AGENDA
NOVEMBER 3, 2026
LAVON CITY COUNCIL
CITY HALL, 120 SCHOOL ROAD, LAVON, TEXAS
REGULAR MEETING
6:30 PM

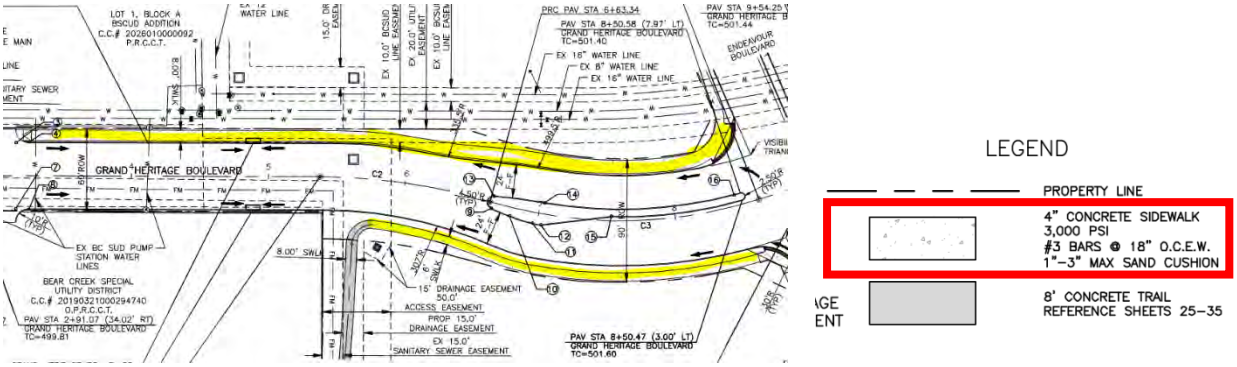
Revise the Final Plat and Paving Plan to detail the 6-foot sidewalks along the following roadways per the PD:

Required public sidewalks shall be constructed as follows:
a. 6 feet along State Highways (where re-construction is necessary to accommodate turn lane improvements)
b. 6 feet wide along Endeavor Boulevard
c. 6 feet wide on Grand Heritage Boulevard, north of Endeavor Boulevard
d. 6 feet wide on the west side of Grand Heritage Boulevard, south of Endeavor Boulevard
e. 6 feet wide on the east side of Grand Heritage Boulevard, south of Endeavor Boulevard
f. 6 feet wide along Geren Drive

Note an example on the Paving Plan, which details 4-foot sidewalks, as shown above:

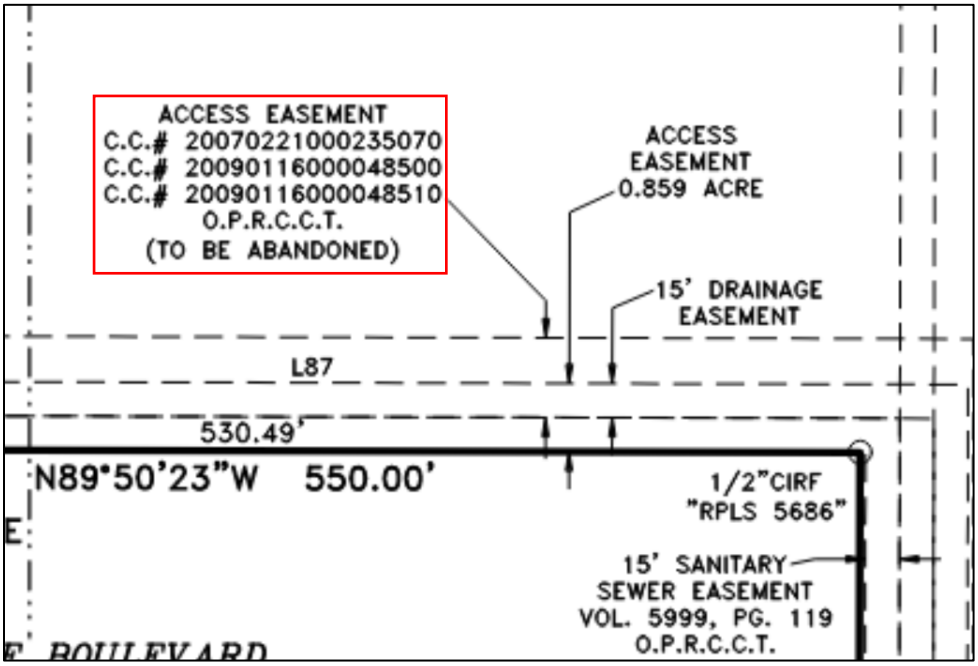
5. Revise the Final Plat to add all existing and proposed easements associated with proposed Lot 6, Block A.

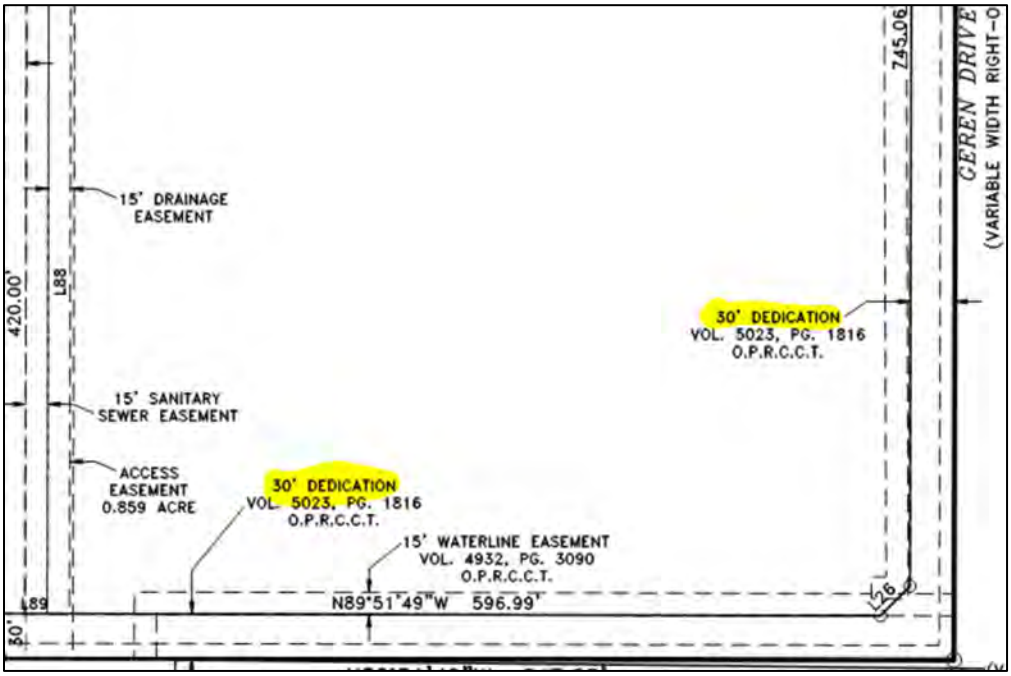
6. Should the three existing access easements be proposed to be abandoned by this plat, revise the Final Plat to update the label to state, “abandoned by this plat.” Please also coordinate with BCSUD to ensure they are informed of this change.

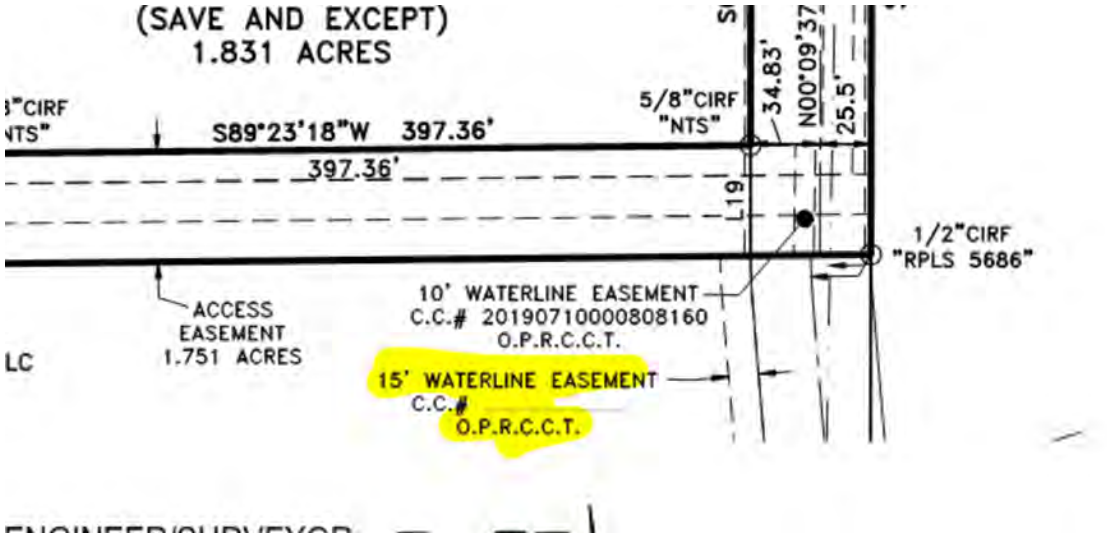
7. Revise the Plat to remove all previously dedicated right-of-way from the subject property:

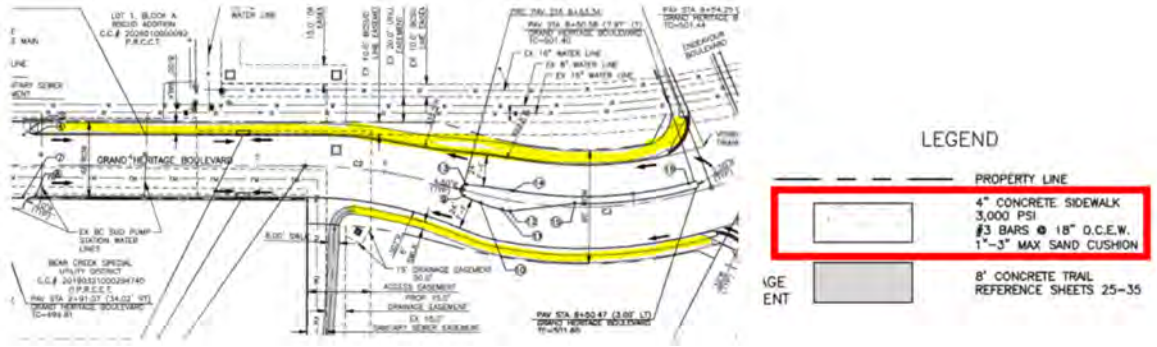
Revise the Final Plat and Paving Plan to detail the 6-foot sidewalks along the following roadways per the PD:

> Required public sidewalks shall be constructed as follows:
> a. 6 feet along State Highways (where re-construction is necessary to accommodate turn lane improvements)
> b. 6 feet wide along Endeavor Boulevard
> c. 6 feet wide on Grand Heritage Boulevard, north of Endeavor Boulevard
> d. 6 feet wide on the west side of Grand Heritage Boulevard, south of Endeavor Boulevard
> e. 6 feet wide on the east side of Grand Heritage Boulevard, south of Endeavor Boulevard
> f. 6 feet wide along Geren Drive

Response: The legend detail specifies the sidewalk as four inches thick, not four feet wide. All sidewalks are proposed as six feet wide, which matches the PD.

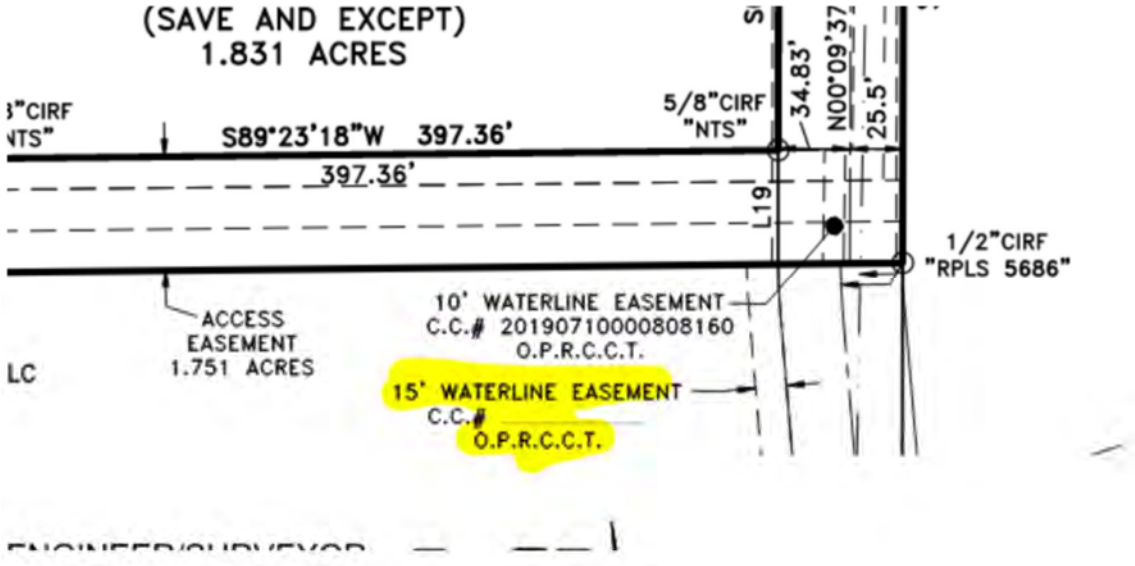
7. Revise the Plat to remove all previously dedicated right-of-way from the subject property:

Response: The 30' dedication by separate instrument recorded in V 5023, P 1861 will need to remain, it is a recorded easement granted to the City.

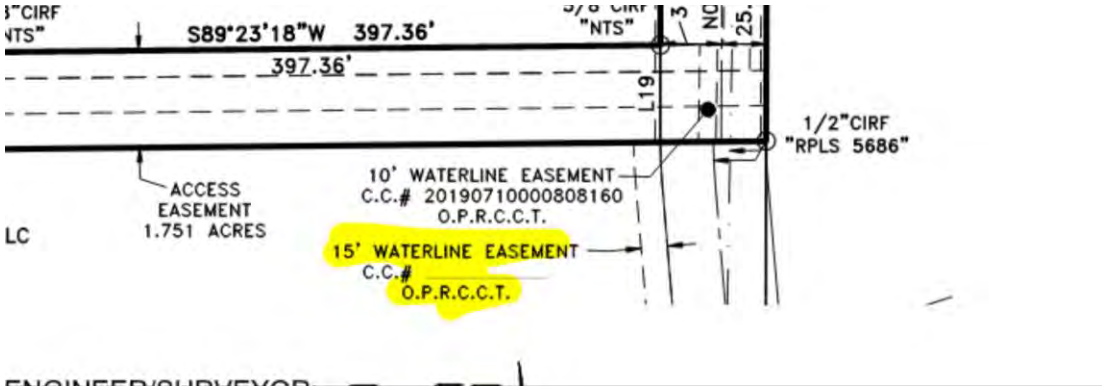
4. **Revise the Plat to remove all previously dedicated right-of-way from the subject property (as highlighted below). The filing information can remain, but the areas should be removed from the subject property, as they are public right-of-way.**
